Comment Letter I104

Response to Comment Letter I104

Re: Boulevard Community Opposing the Proposed Soitec Solar Projects

I104-9	This comment includes photos of the visual character of the Proposed Project area. Refer to the response to comment I104-6.
Attachment Comment I104-9

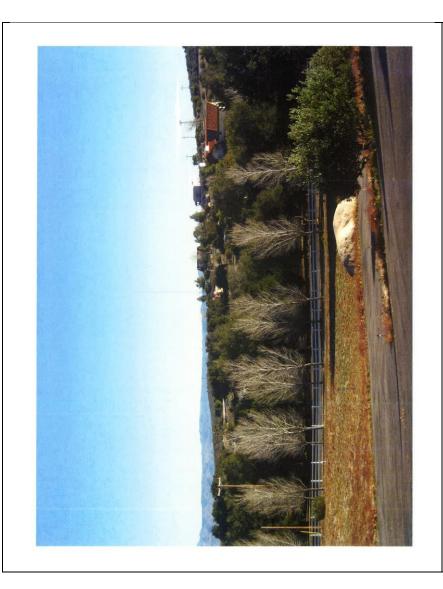
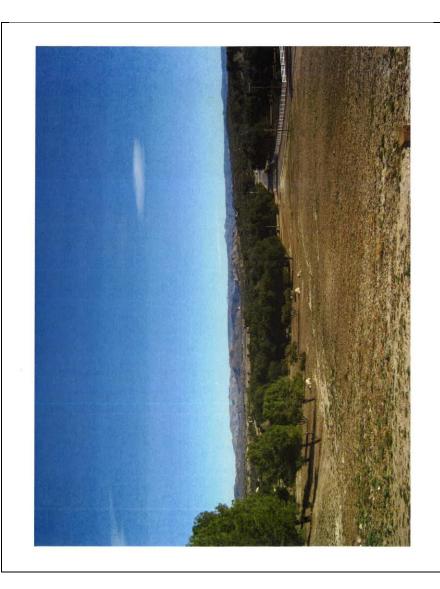
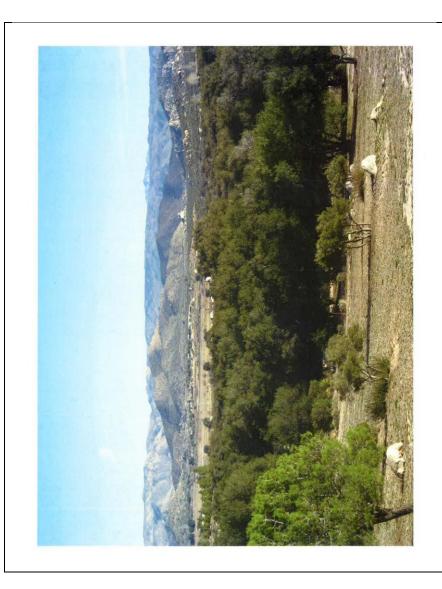
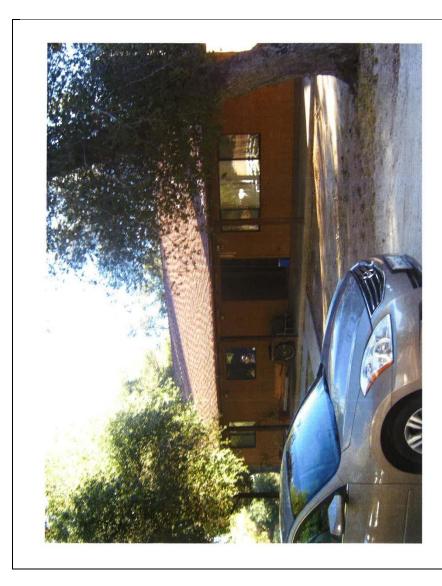
access these residences. Therefore, local residents' exposure to the project site is anticipated to be similar as motorists on Interstate 8 or McCain Valley Road." This statement is untrue. Please find the attached photos for review showing the TRUE reflection of our community and homes. These photos were taken from the back yards of residences' of several homes located in the Rancho Boulevard Estates looking east directly to the proposed Rough Acres site. Most assuredly, the residents of the Boulevard Estates will lose their visual beauty if solar project is approved.

The County appreciates the photos submitted by the commenter. These will be included in the FPEIR for review and consideration by the decision makers. It should be noted that per CEQA Guidelines (14 CCR
